TECHNICAL BULLETIN

407-20-133

MODEL AFFECTED: 407

SUBJECT: ENGINE TORQUE, ENGINE OIL PRESSURE, AND
TRANSMISSION OIL PRESSURE INDICATION
SYSTEMS, MODIFICATION OF

Figure 1 – Heat shrink sleeve installation

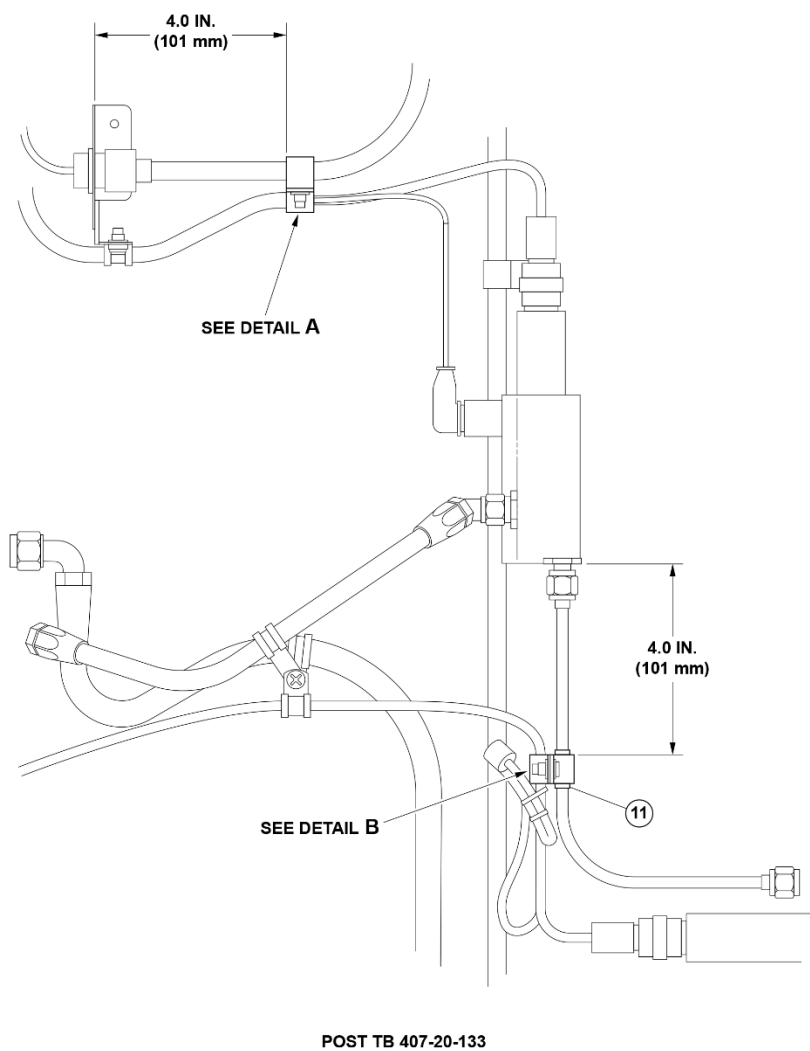
PART I of this technical bulletin provides instructions to replace the connectors MS3116F8-4S with new connectors 160-027-508, and add heat shrink sleeves on each transducer wire harness to fill the gap between the wires and the connector inserts.

6. Install and apply heat to the heat shrink sleeve (1, Figure 1), and install a new contact (2) on each wire as shown in Figure 1 (BHT-ELEC-SPM).

1. Heat shrink sleeve (2530-00246-00)
2. Contact (10-597817-351)

Figure 2 – Re-orient the clamps

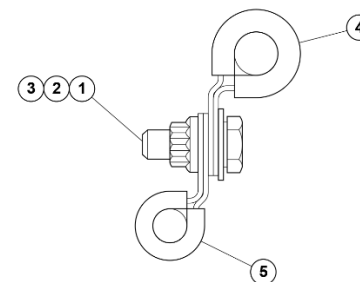
PART II of this technical bulletin provides instructions to re-orient clamps to improve water drip loops.

3. Remove and retain the screw (1, Figure 2), the nut (2), the washers (3) and the clamps (4 and 5) for the transmission oil pressure transducer (1G6) wire harness.

4. Re-orient and install the clamps (4 and 5) with the screw (1), the nut (2) and the washers (3), as shown in Figure 2.
5. Remove and retain the screw (6), the nut (7), the washers (8) and the clamps (9 and 10) for the engine torque transducer (1B7) wire harness.

6. Wrap the insulation tape (11) on the tube. Re-orient and install the clamps (9 and 10) with the screw (6), the nut (7) and the washers (8), as shown in Figure 2.
